CITY OF SACRAMENTO PLANNING COMMISSION
 1231 "I" STREET, SUITE 200, SACRAMENTO, CA 95814

- APPLICATION:**
- A. Negative Declaration.
 - B. Rezone 1.47± vacant acres from Standard Single Family (R-1) to the Single Family Alternative (R-1A) zone.
 - C. Tentative Map to subdivide one 1.47± vacant parcel into 8 lots in the proposed Single Family Alternative (R-1A) zone.
 - D. Special Permit to develop 8 single family homes on 8 lots in the proposed Single Family Alternative (R-1A) zone.

LOCATION: South side Dias Avenue, approximately 1000 feet east of Stockton Boulevard

TENTATIVE SUBDIVISION MAP
DIAS PARK
CITY OF SACRAMENTO SEPTEMBER 1990

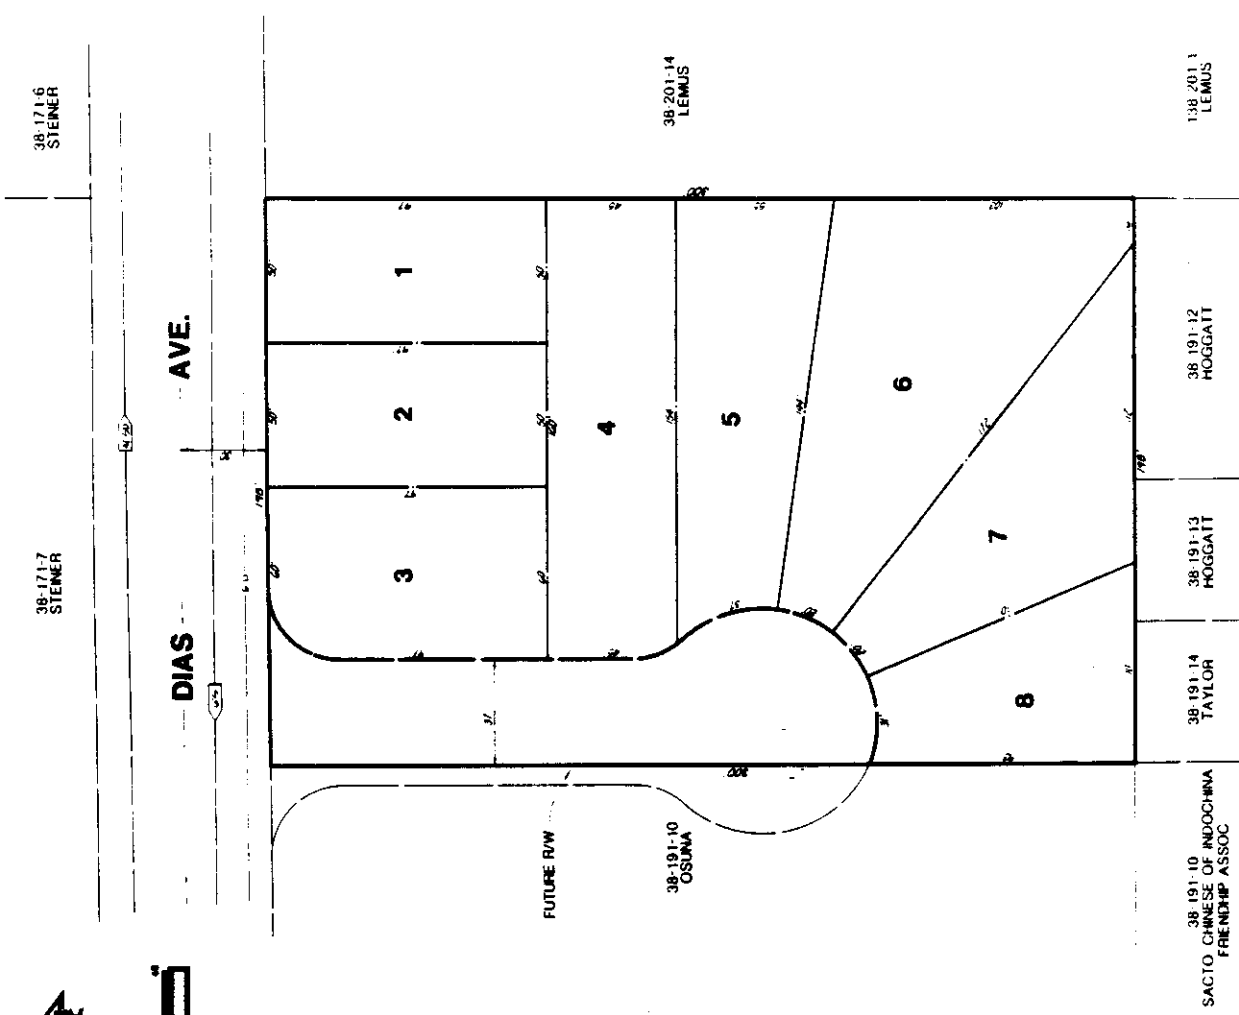
The proposed tentative map divides the site into eight lots. The proposal consists of a cul-de-sac running along the western property line. The cul-de-sac is shown at a 37 foot right-of-way on the applicant's site. The remainder of the cul-de-sac will be constructed when the adjacent parcel is developed. The City Fire Department has reviewed the proposal and found that building that portion of the cul-de-sac which is on the subject property is adequate as long as it eventually becomes a standard cul-de-sac.

The lot layout shows five lots fronting on the cul-de-sac. The three remaining parcels front on Dias Avenue. The depth of the parcels on Dias are shown at 97 feet. The Dias Avenue is a 60 foot right-of-way. In actuality, the right-of-way will be developed to only 54 feet. This leaves an additional three feet of front yard area for the parcels. The City does not plan to abandon this additional right-of-way, however, there are no plans to widen the street to the full 60 feet.

Lots 5, 6, 7, and 8 have relatively narrow street frontages due to the cul-de-sac. The lots, however, are adequate in size to accommodate a standard single family residence. Staff recommends the setbacks on these four parcels be 35 feet.

1. Provide standard subdivision improvements pursuant to Section 40.811 of the City Code including 27 foot half street along Dias Avenue and minimum 22 foot half street cul-de-sac and 12 foot paved lane westbound on Dias Avenue and southbound on cul-de-sac. Drainage on the west side of cul-de-sac shall be provided for in a ditch or curb and gutter;
2. Prepare a sewer and drainage study for the review and approval of the City Engineer;

11. Record on the final map a 35 foot front setback on lots 5, 6, 7, and 8.
12. Place a note on the final map: The applicant shall comply with the mandatory mitigation measures of the Environmental Coordinator on file in the Planning Division (P90-403).

ELEVATIONS
PLAN 1 DIAS PARK
CITY OF SACRAMENTO SEPT. 1990
SCALE: 1"=1/8"

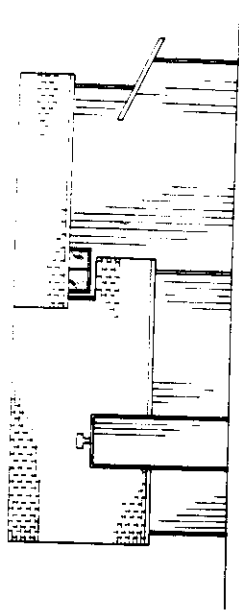
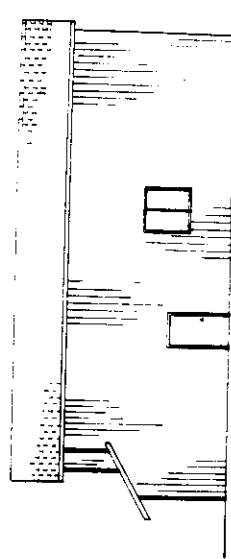
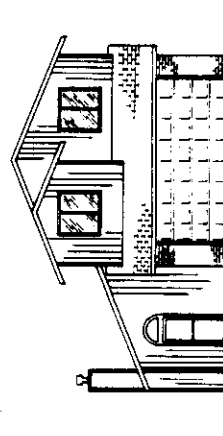
The proposed elevations consist of T1-11 siding with masonry trims. Staff suggests the applicant revise the elevations and submit for review and approval of Design Review Staff prior to the issuance of Building Permits. The revised elevations should include a more pronounced entrance for the units and increasing the number of windows on some of the elevations, specifically the east and west elevations of Plan 2. The revised elevations should, in a very detailed fashion, specify the type of materials to be used. T1-11 is a building material that requires careful consideration. The adequacy of architectural features will determine the appropriateness of whether it will be an acceptable material. The revised elevations should specify the masonry trim materials as well as window and door trims. The roof material is also important. Generally, laminated dimensional composition shingles with a minimum 25 year rating are suggested. Staff also suggests metal garage doors with raised panel design. Special attention should be paid to building design on the corner lot (Lot 3) of the subdivision.

1. The applicant shall submit a master site plan be showing which of units will be located on each lot with the setbacks to be provided, for review of the Planning Director prior to the issuance of Building Permits. The front setbacks should range from 25 to 35 feet.
2. Lots 5, 6, 7, and 8 shall have a minimum of 35 foot front setbacks.
3. The applicant shall submit revised, detailed, elevations for review and approval of Design Review Staff prior to the issuance of Building Permits. Design Review Staff shall address, at a minimum, the exterior siding material and trim, roof material, enhanced front entrance to the unit, and increased number of windows. The corner lot (Lot 3) shall also have an enhanced elevation for the street side elevation.
